Access Compliance Report

Public Rights-of-Way

Intersection ID: 10035419	Main Street: RANDOLPH_RD	Cross Street: N/A	Location: SE
ADA ID: 68A60C828001	Ramp Type: Perp	Initial Pass/Fail: Fail	Overall Compliance: No
Codes/Mitigation Info/Possible Solution		Field Measurements/Component Compliance	
Severity Score: 50

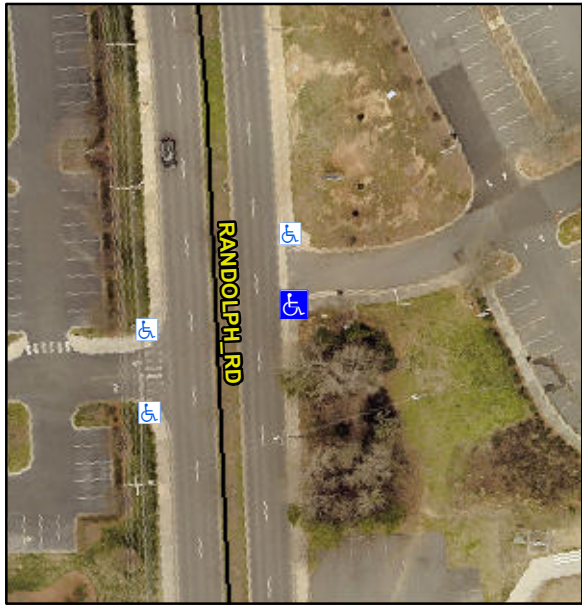
Possible Solutions:					
	Remove & Replace Entire Ramp.					
	Surveyor Notes:					
	N/A					
	PROW/ADA:					
	Not Found, R304.2.2, R304.5.3					
	Street 1 Name		ENTRANCE			
	Stop Condition-Street 2		StopSign			
	Street 2 Name		N/A			
	Stop Condition-Street 1		N/A			
Total Cost:		\$	1850.00

Compliance	Description	Data	Compliance	Description	Data
N/A	Ramp Length (in)	69.0	No	Ramp Slope (%)	12.7
Yes	Ramp Width (in)	48.0	No	Ramp XSlope (%)	9.6
N/A	Flare Type LT	N/A	N/A	Flare Type RT	N/A
N/A	Flare Slope LT (%)	N/A	N/A	Flare Slope RT (%)	N/A
N/A	Flare Traversable LT?	N/A	N/A	Flare Traversable RT?	N/A
N/A	Landing Length (in)	N/A	N/A	DWS Provided?	N/A
N/A	Landing Width (in)	N/A	N/A	DWS Contrast?	N/A
N/A	Landing Slope (%)	N/A	N/A	DWS Length (in)	N/A
N/A	Landing X Slope (%)	N/A	N/A	DWS Full Width?	N/A
N/A	Landing Curb? (Y/N)	N/A	N/A	DWS Offset (in)	N/A
N/A	Shared Landing?	N/A			
N/A	Gutter Ponding?	N/A	N/A	Gutter Slope (%)	N/A
N/A	Gutter Lip Ht (in)	N/A	N/A	Gutter X Slope (%)	N/A
N/A	Painted X Walk1?	No	N/A	Painted X Walk2?	N/A
	X Walk 1 Direction	To N		X Walk 2 Direction	N/A
N/A	X Walk 1 Width (in)	N/A	N/A	X Walk 2 Width (in)	N/A
	X Walk 1 Slope (%)	2.8		X Walk 2 Slope (%)	N/A
	X Walk 1 X Slope (%)	10.5		X Walk 2 X Slope (%)	N/A
